SEQUOYAH NUCLEAR PLANT UNIT 1 AND UNIT 2

IMPROVED TECHNICAL SPECIFICATIONS CONVERSION

ITS CHAPTER 2.0 SAFETY LIMITS

**Current Technical Specification (CTS) Markup
and Discussion of Changes (DOCs)**

Figure 2.1-1 Reactor Core Safety Limit—Four Loops in Operation

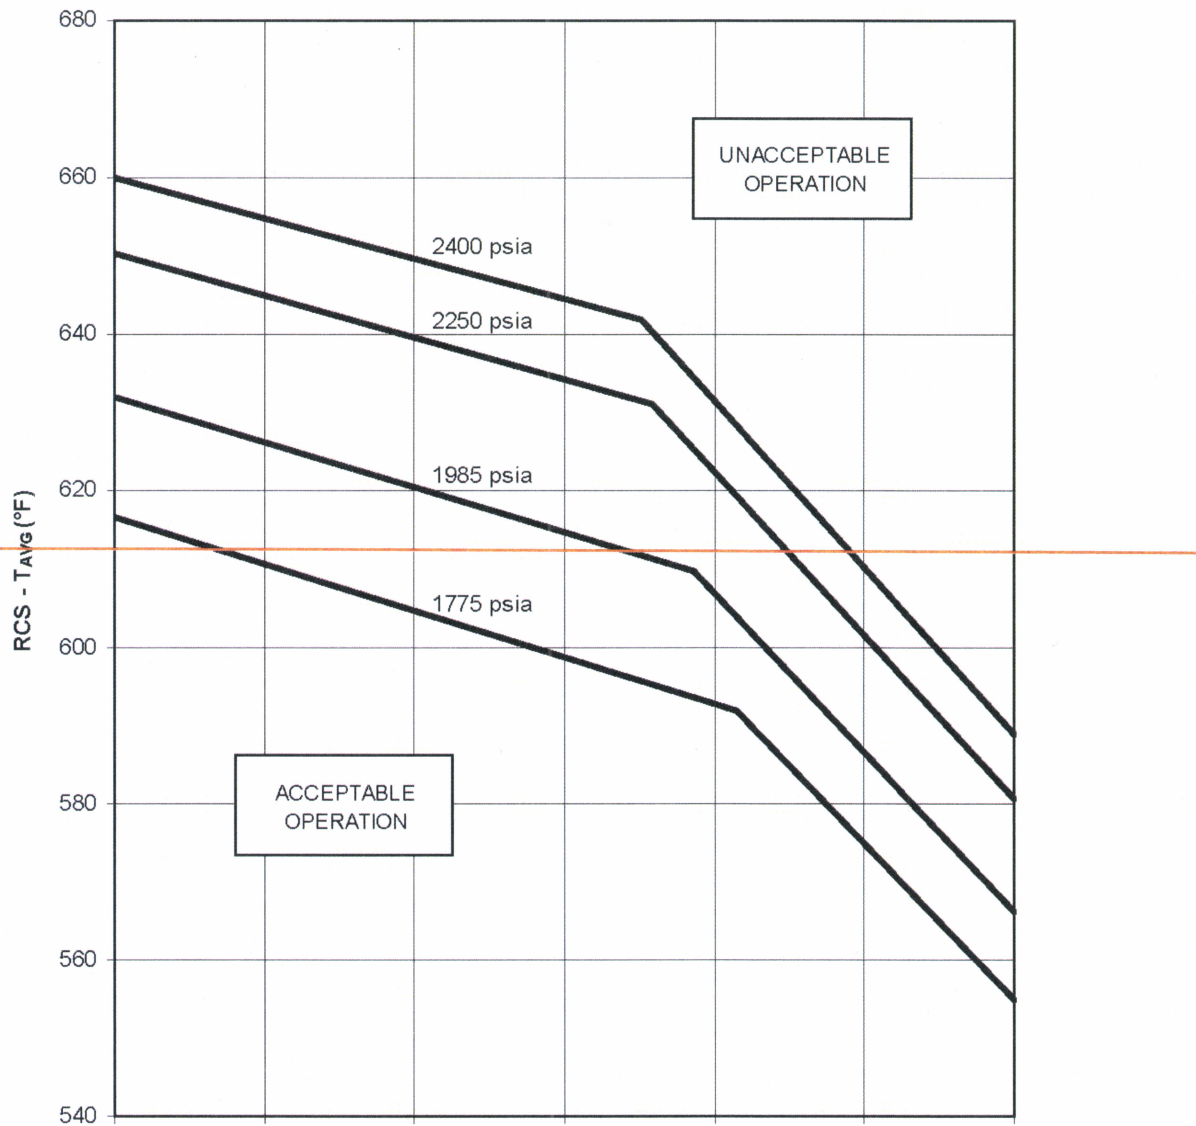
2.1.1 The combination of THERMAL POWER, pressurizer pressure, and the highest operating loop coolant temperature (Tavg) shall not exceed the limits ~~shown in Figure 2.1-1~~ and the following SLs shall not be exceeded:

in the COLR

LA01

This page deleted.

- LA01 *(Type 6 – Removal of Cycle – Specific Limits from the Technical Specifications to the Core Operating Limits Report)* CTS 2.1.1 requires the combination of THERMAL POWER, pressurizer pressure, and the highest operating loop coolant temperature (T_{avg}) not to exceed the limits shown in Figure 2.1-1. ITS 2.1.1 states the combination of THERMAL POWER, Reactor Coolant System (RCS) highest loop average temperature, and pressurizer pressure shall not exceed the limits specified in the COLR. This changes the CTS by moving limits that must be confirmed on a cycle specific bases to the COLR. The Reactor Core safety limits are retained in Technical Specification Chapter 2.0.

Figure 2.1-1 Reactor Core Safety Limit-Four Loops in Operation

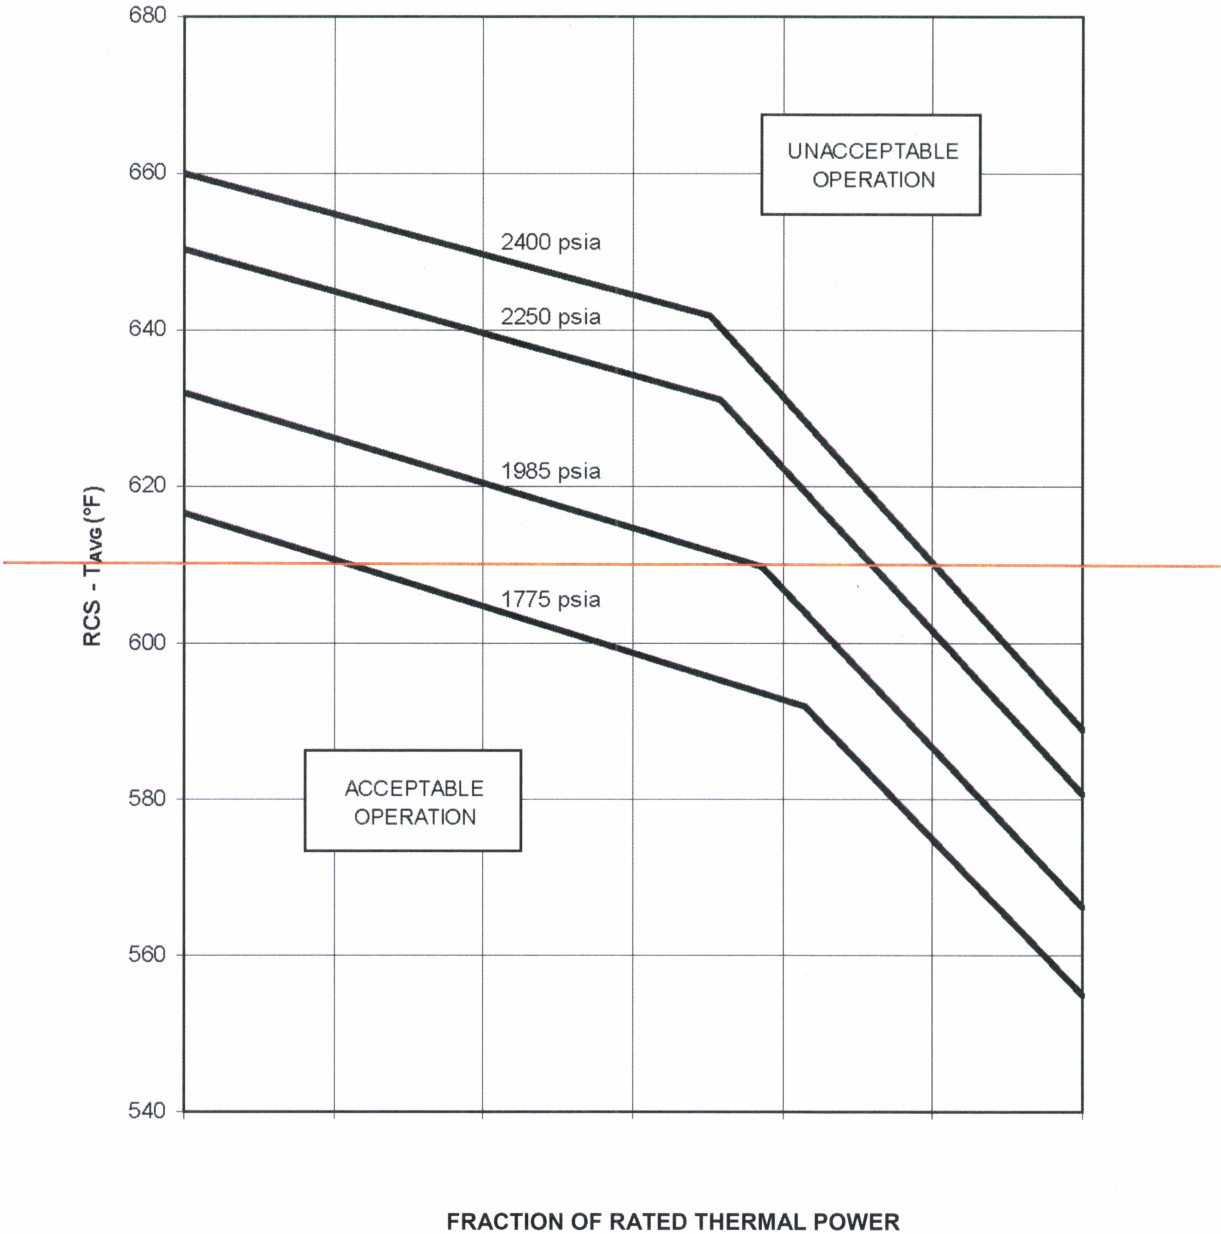
2.1.1 The combination of THERMAL POWER, pressurizer pressure, and the highest operating loop coolant temperature (T_{avg}) shall not exceed the limits ~~shown in Figure 2.1-1~~ and the following SLs shall not be exceeded:

in the COLR

LA01

This page deleted.
